[Docket No. FAA-2006-24074; Directorate Identifier 2005-NM-213-AD]

#### Airworthiness Directives; Bombardier Model CL-600-2C10 (Regional Jet Series 700, 701, & 702) Airplanes, Model CL-600-2D15 (Regional Jet Series 705) Airplanes, and Model CL-600-2D24 (Regional Jet Series 900) Airplanes

**ACTION:** Notice of proposed rulemaking (NPRM).

**Figure 1**  
**LH side shown**  
**RH side opposite**

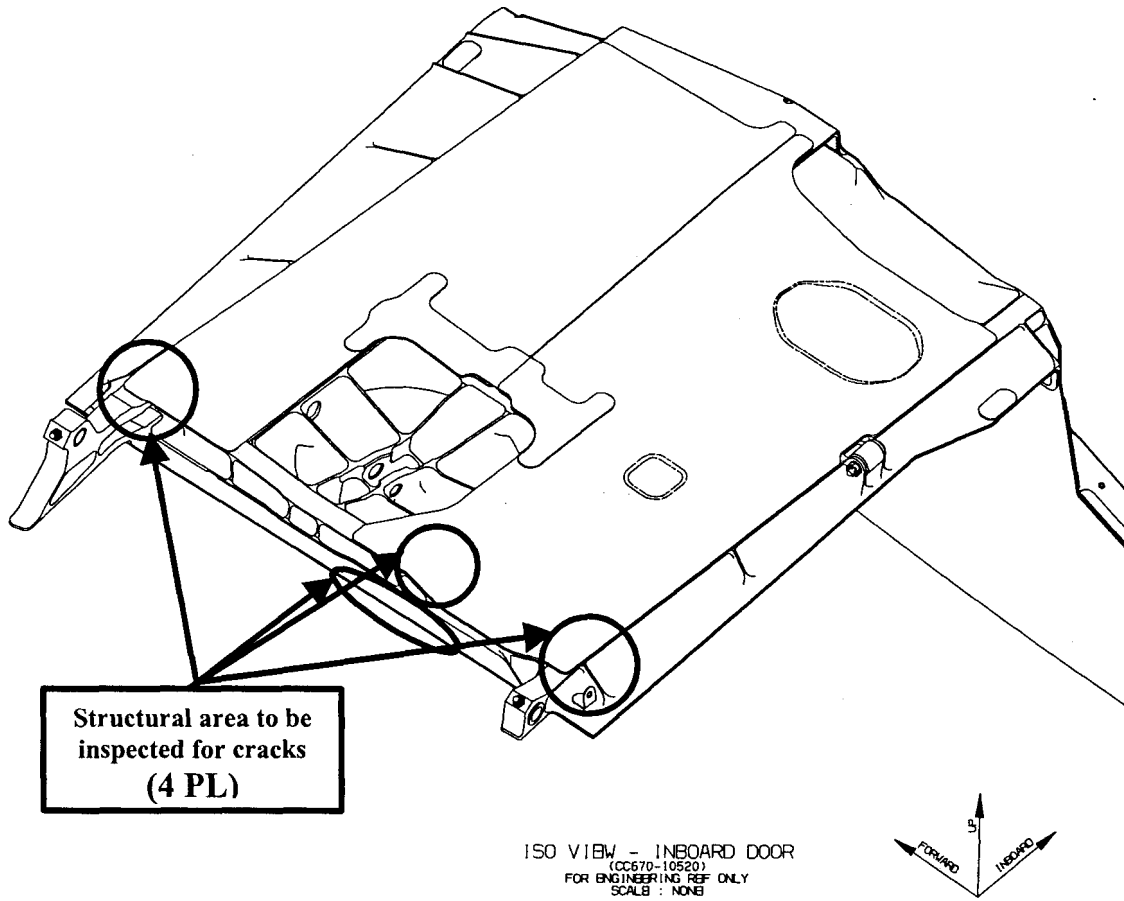
(g) For Model CL-600-2C10 (Regional Jet series 700 & 701) series airplanes, S/Ns 10003 through 10999 inclusive; and Model CL-600-2D24 (Regional Jet series 900) series airplanes, S/Ns 15002 through 15990 inclusive: At the applicable time specified in paragraph (f) of this AD, perform detailed inspections of the lower panel, part number (P/N) CC670-10520, of the left- and right-hand MLG doors for the conditions and in the areas specified in paragraphs (g)(1), (g)(2), (g)(3), and (g)(4) of this AD; and Figures 1, 2, and 3 of this AD.

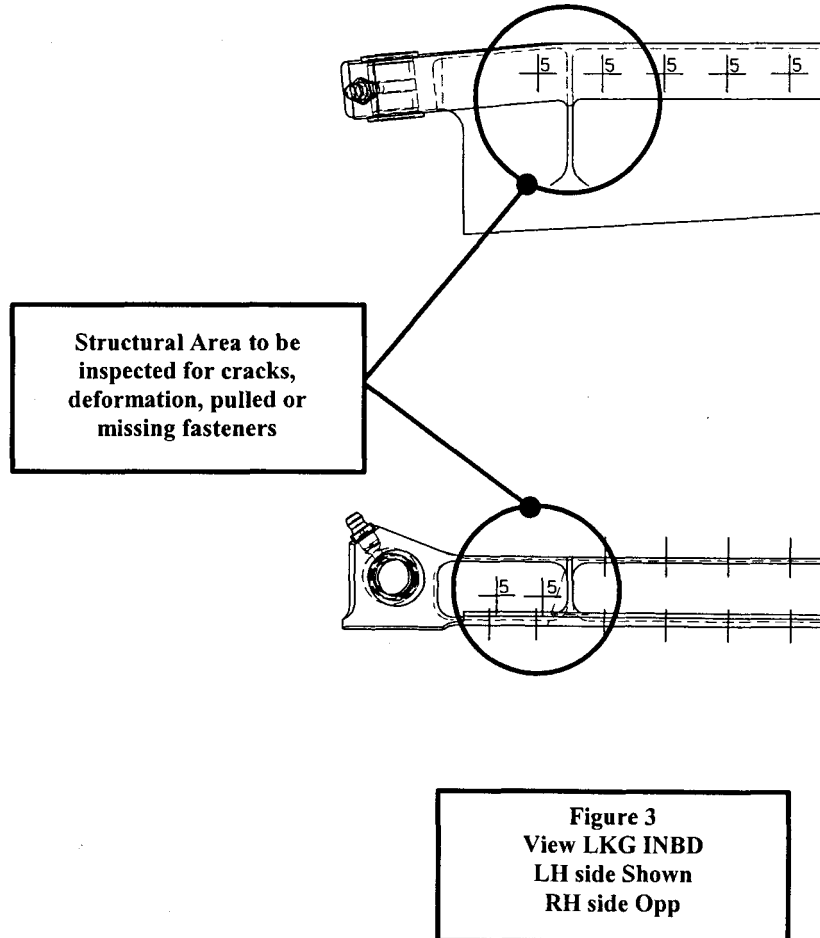
(1) Inspect the cross member, P/N CC670-10572, of the MLG door lower panel for cracking or deformation, in accordance with Figure 2 of this AD.

(2) Inspect the inner skin, P/N CC670-10577, of the MLG door lower panel at the

cross member (P/N CC670-10572) for cracking or deformation, or pulled or missing fasteners, in accordance with Figure 2 of this AD.

(3) Inspect the outer skin, P/N CC670-10574, of the MLG door lower panel at the cross member (P/N CC670-10572) for cracking or deformation, or pulled or missing

fasteners, in accordance with Figure 2 of this AD.

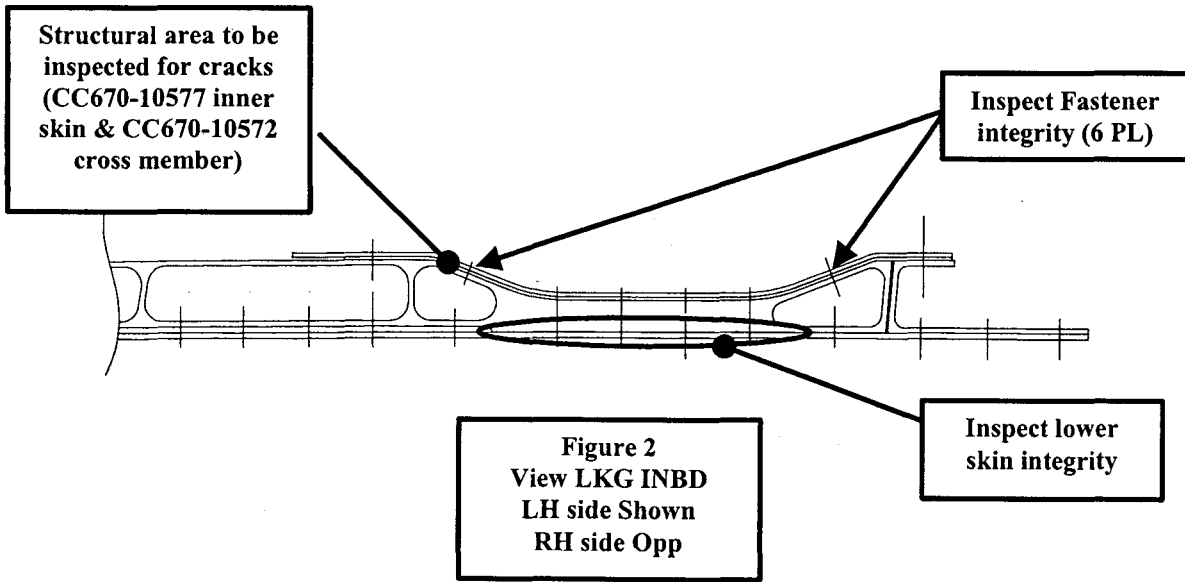
(4) Inspect the forward member, P/N CC670-10570, and aft member, P/N CC670-10571, of the MLG door lower panel, for cracking or deformation, or pulled or missing fasteners, in accordance with Figure 3 of this AD. Figures 1 through 3 of this AD follow.
